Notice of Allowability	Application No.		Applicant(s)	
	10/801,439		MYERS ET AL.	
	Examiner		Art Unit	
	Ehud Gartenberg		3746

EXAMINER'S AMENDMENT

CONTROLLED PRESSURE
FUEL NOZZLE SYSTEM
INVENTOR: WILLIAM J. MYERS, et al.
DOCKET: 123102
ATTY: STEVEN J. ROSEN; PHONE: (513) 489-5383

FIG. 11

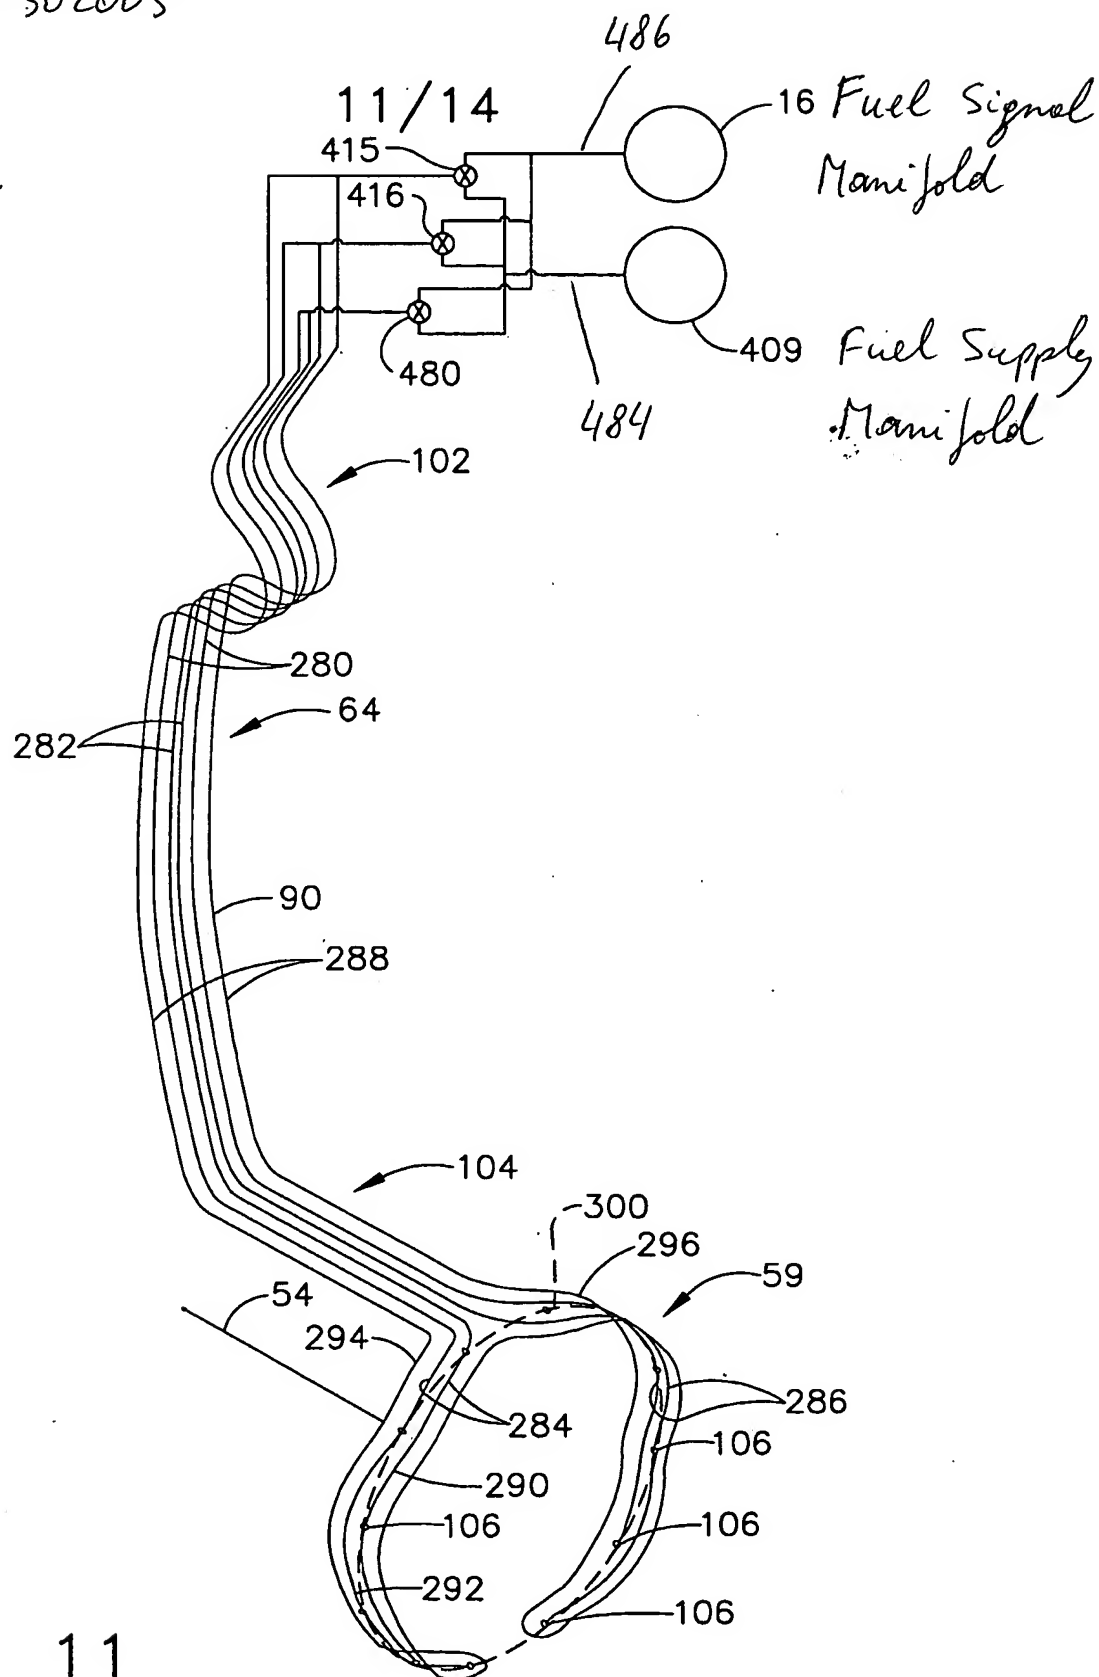
The application has been amended as follows: Figure 11 has been selected to be printed on the face of the patent, and has been amended by the Examiner to include and verbally explain some of the most important features and elements of the claimed invention.

2. New corrected drawing of Figure 11 in compliance with 37 CFR 1.121(d) are required in this application because Figure 11 has been amended by the Examiner. Applicant is advised to employ the services of a competent patent draftsman outside the Office, as the U.S. Patent and Trademark Office no longer prepares new drawings. The corrected drawings are required in reply to the Office action to avoid abandonment of the application. The requirement for corrected drawings will not be held in abeyance.
